Haweswater Aqueduct Resilience Programme - Proposed Bowland Section

Supplementary Environmental Information Report

Project No: B27070CT
Document Title: Proposed Bowland Section
Supplementary Environmental Information Report
Document Ref.: LCC_RVBC-BO_SEI
Revision: 0
Date: February 2022
Client Name: United Utilities Water Ltd

Legend

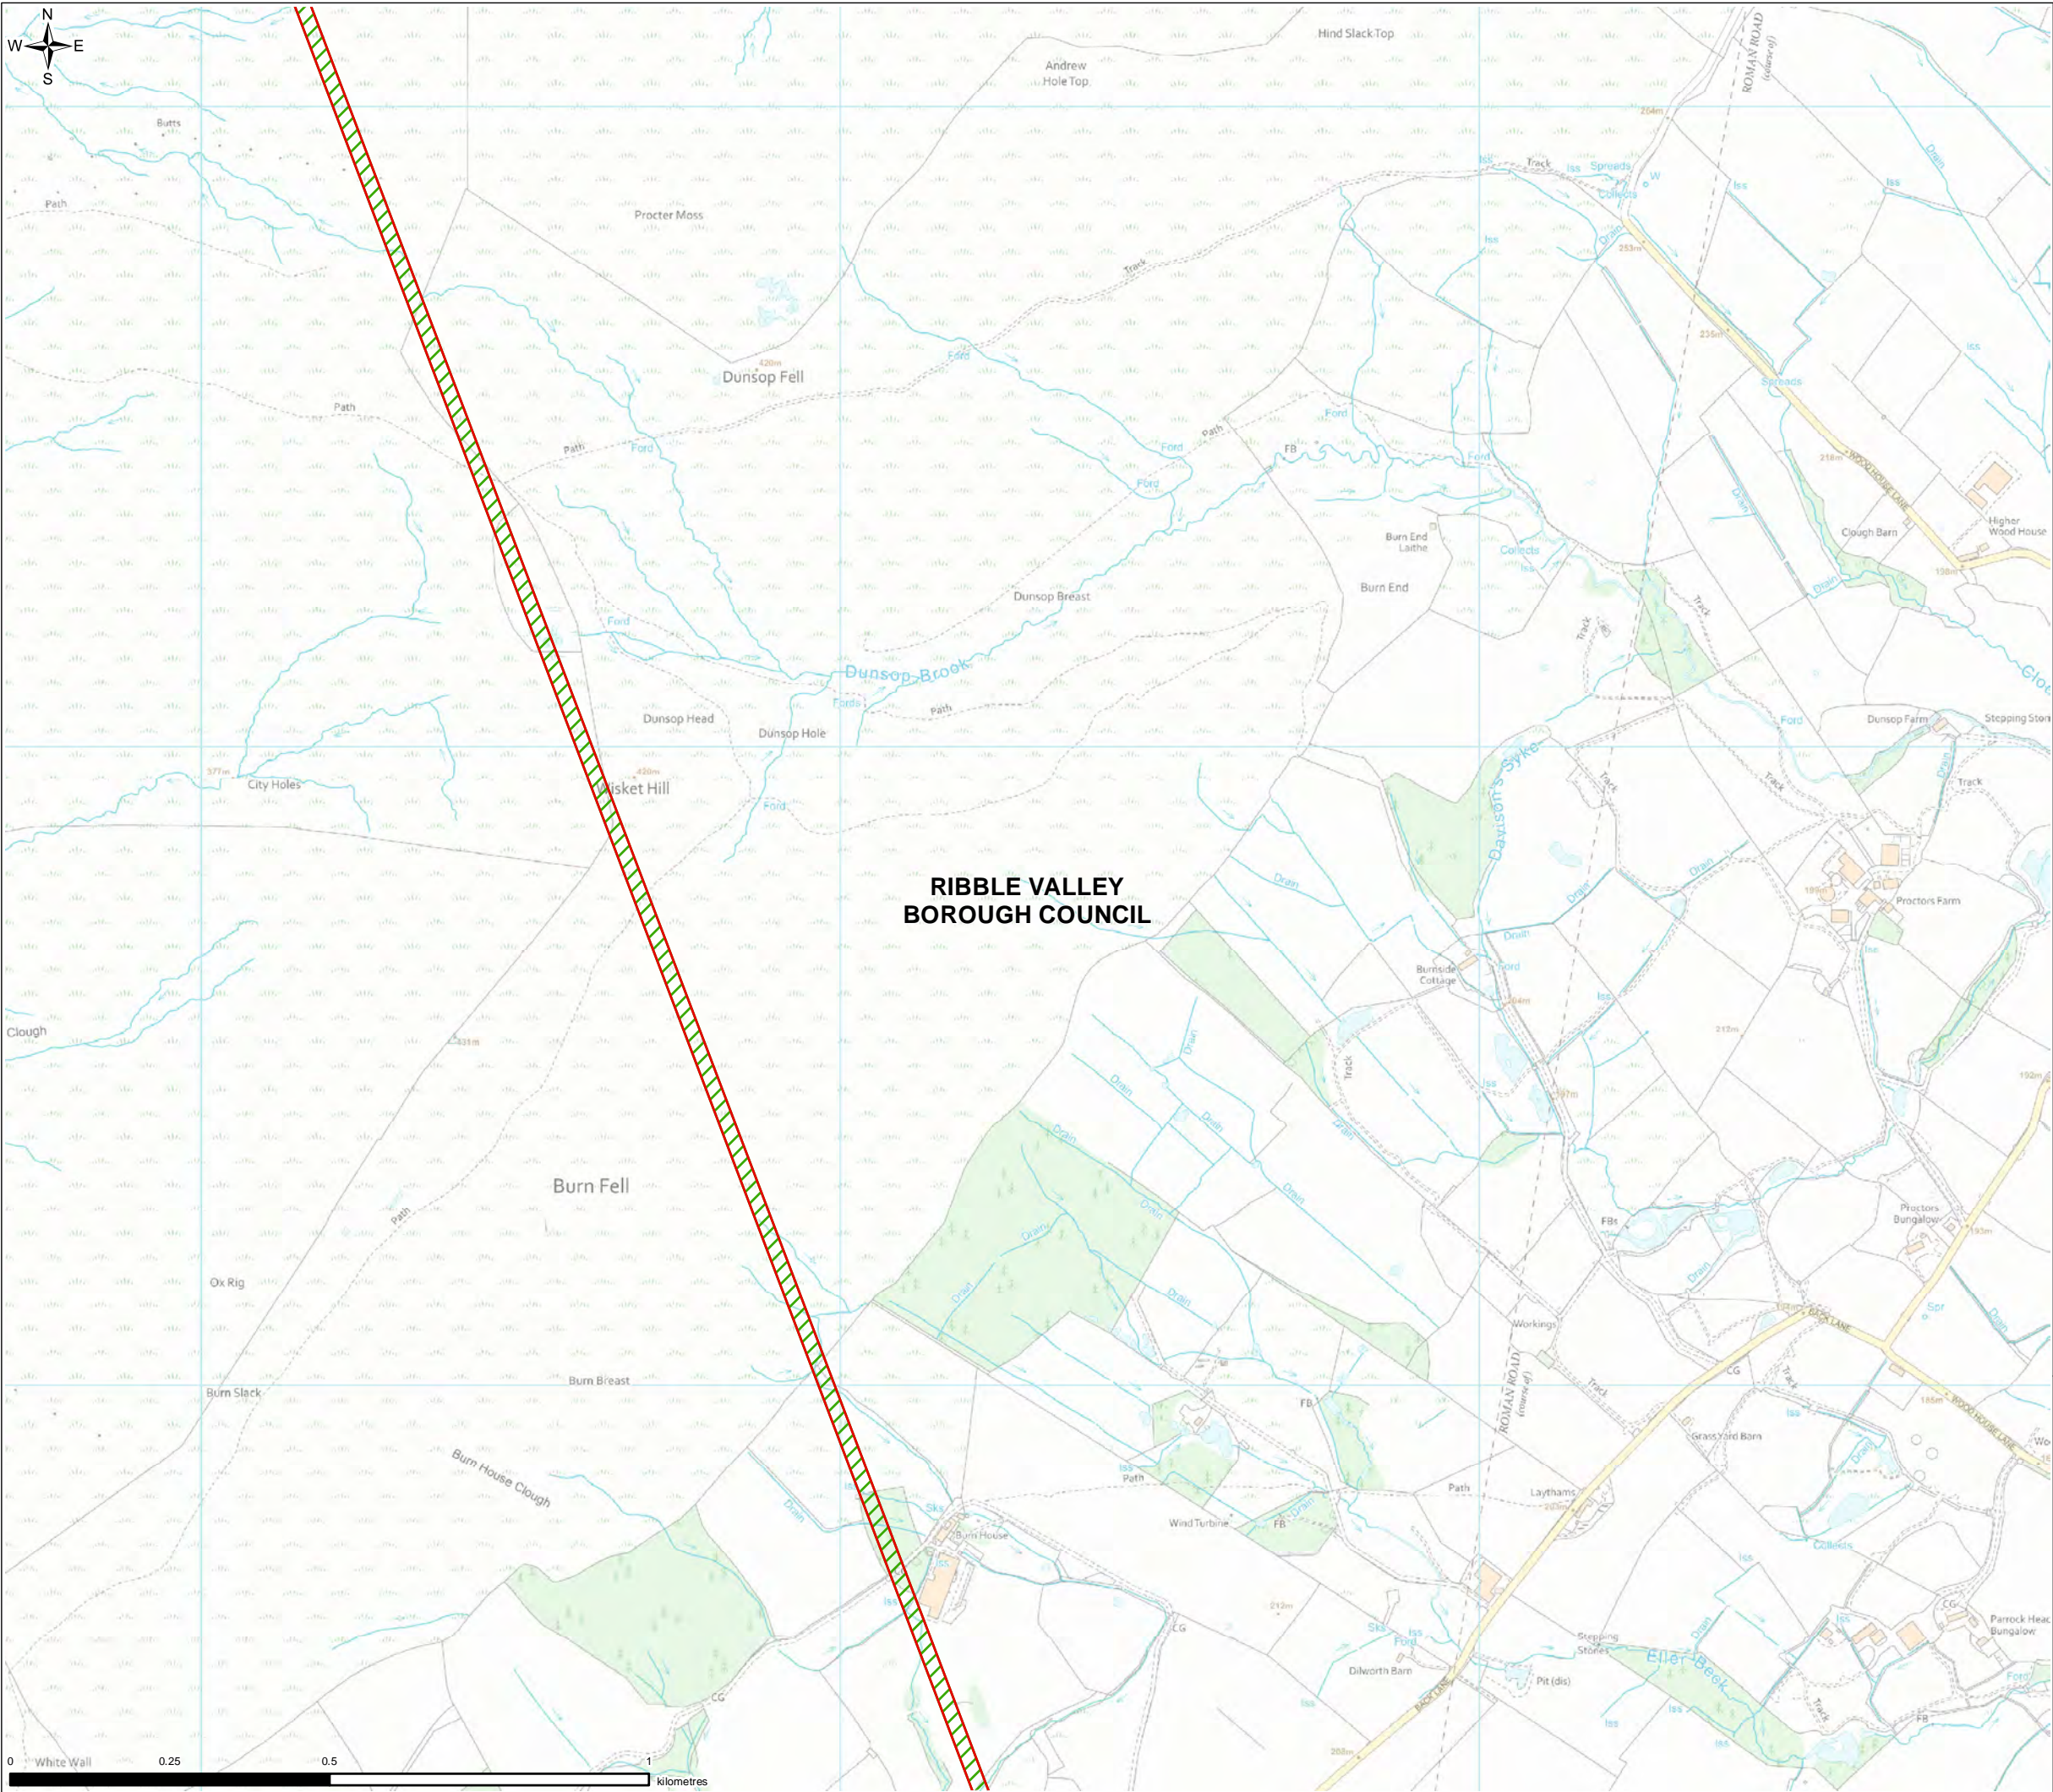
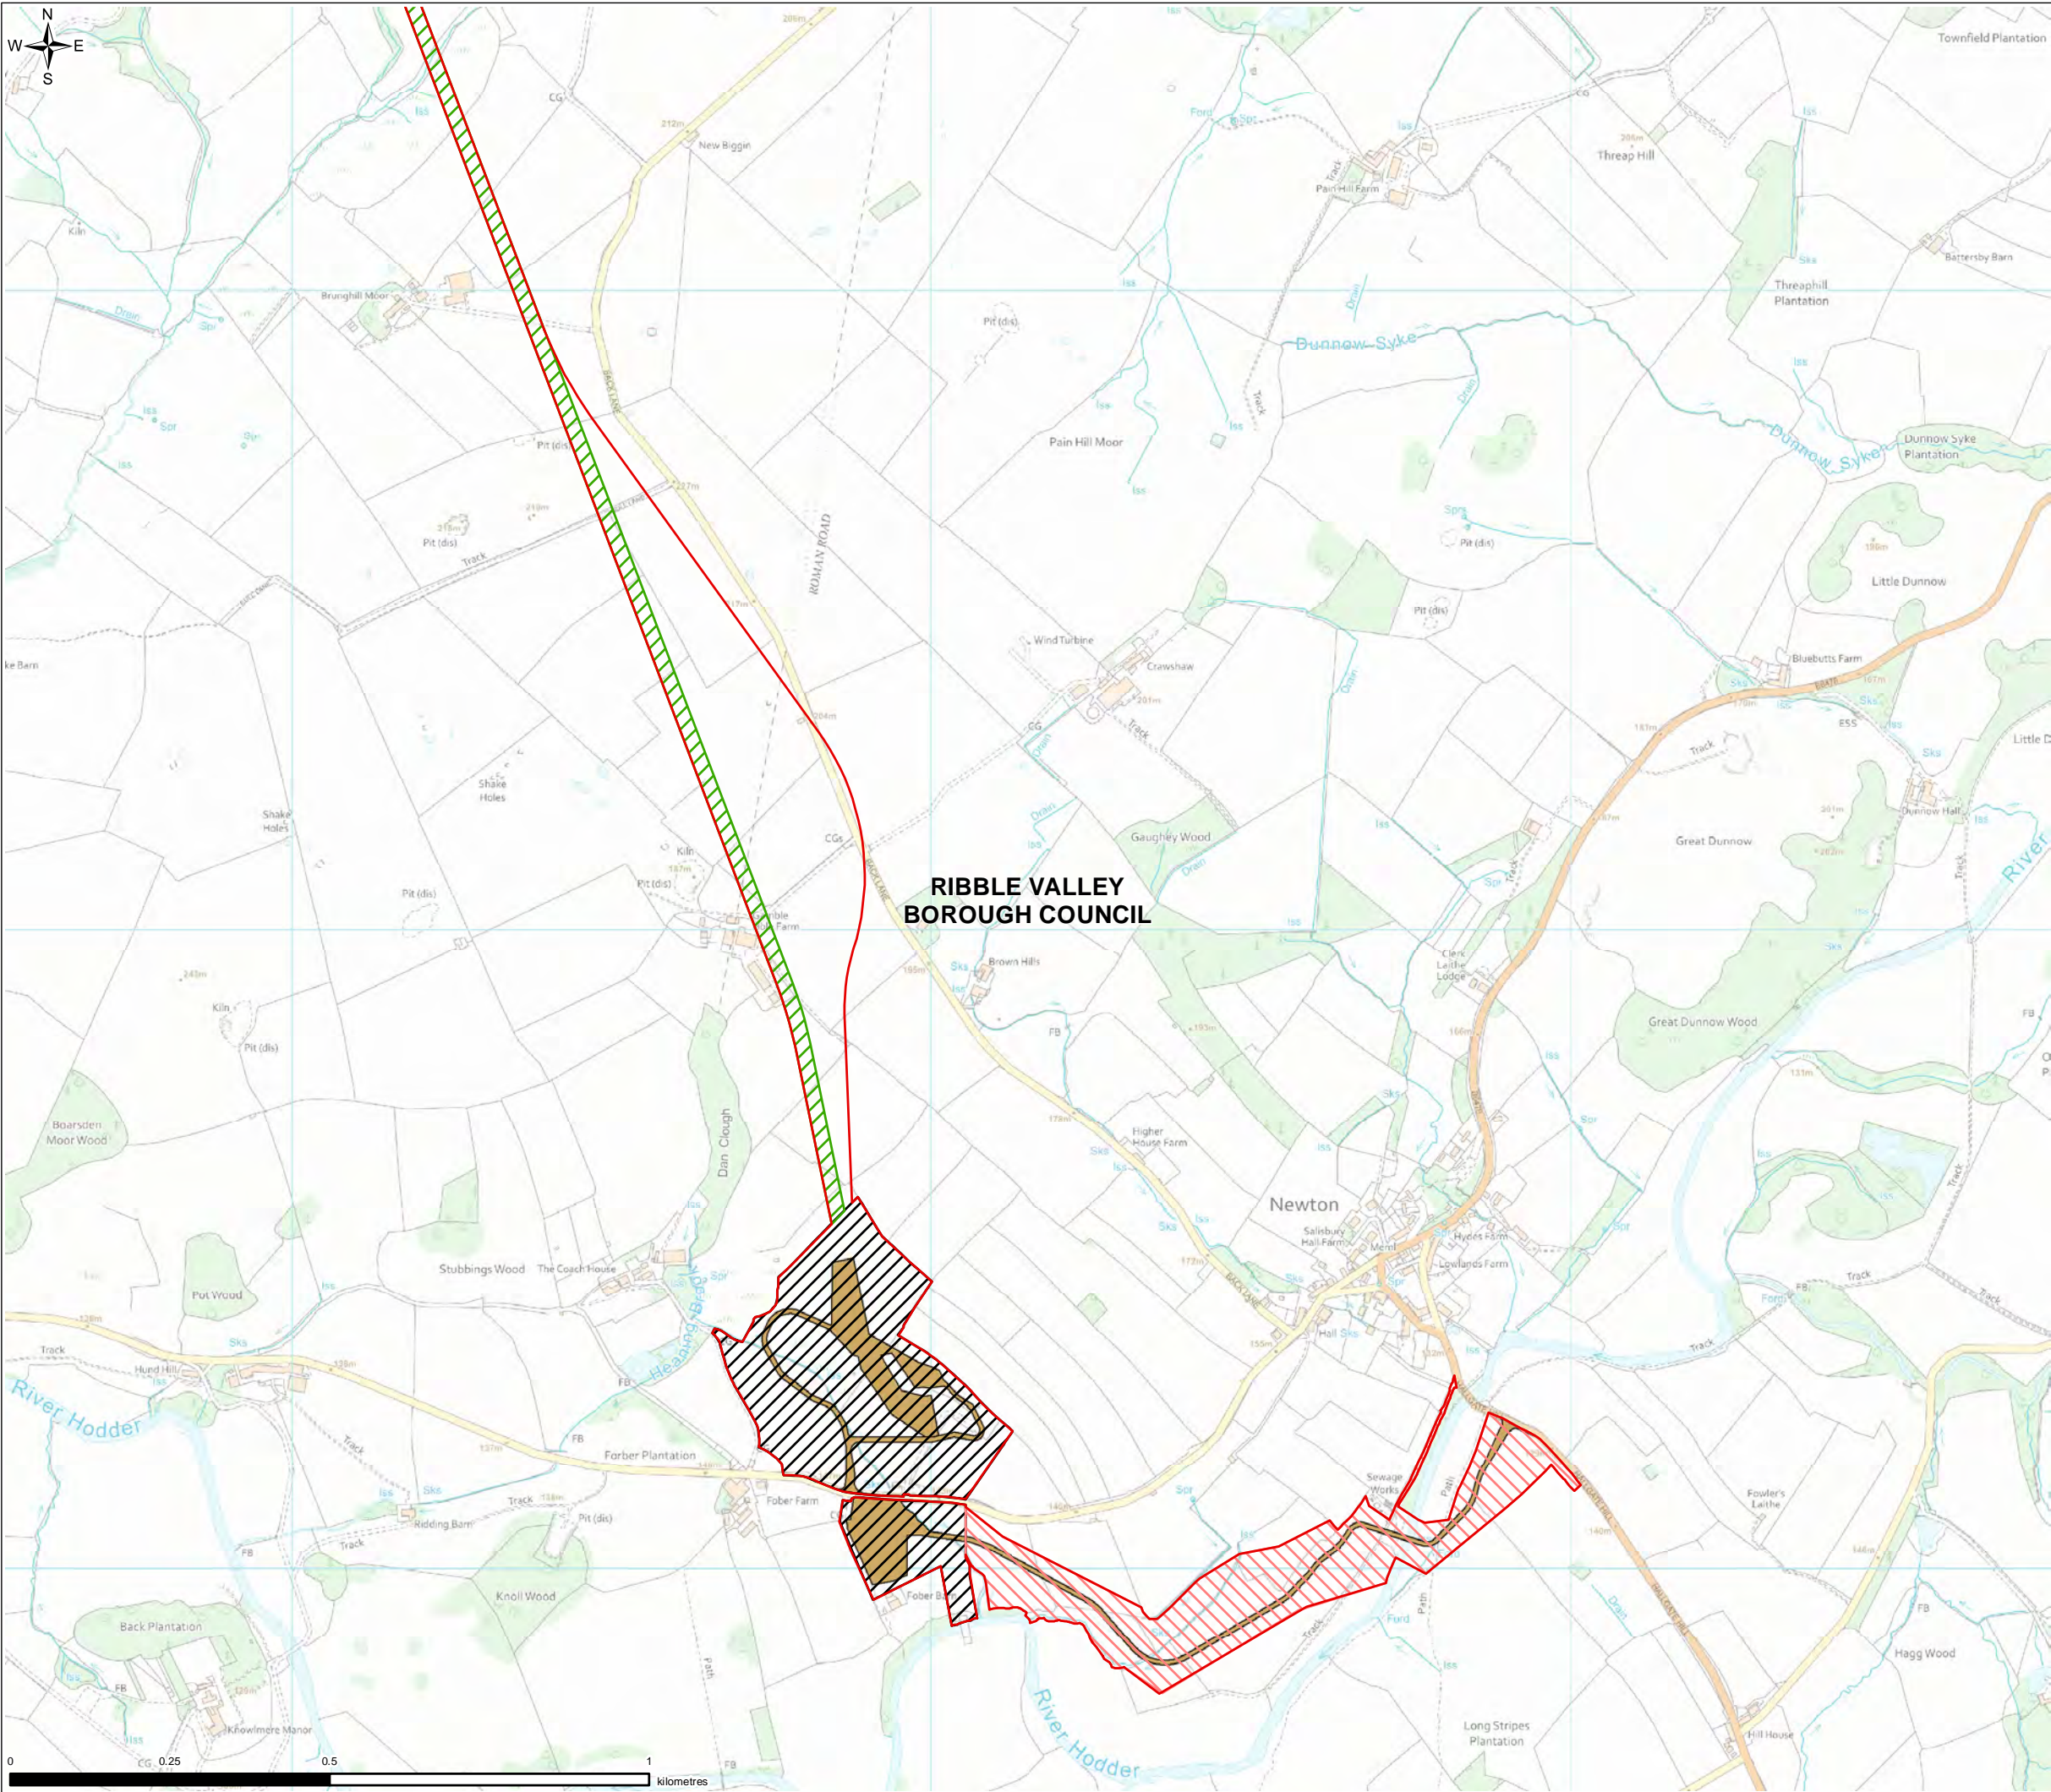
- 28) Figures 3.1a and 3.1b present the updated planning application boundaries for the Proposed Bowland Section; more detailed and larger scale drawings are provided in the February 2022 Revised Planning Application documents. Figure 3.1a focuses on the main construction compounds and the route of the tunnel below ground level. Figure 3.1b shows all the elements of the Proposed Bowland Section at a smaller scale, including satellite compounds and off-site highways works.
- 29) A screening exercise has been undertaken to identify where likely significant effects may arise in relation to the changes and new proposals. This has involved testing the proposed changes against each EIA topic to establish whether any likely significant effect may arise. The outcomes are summarised in Table 6.
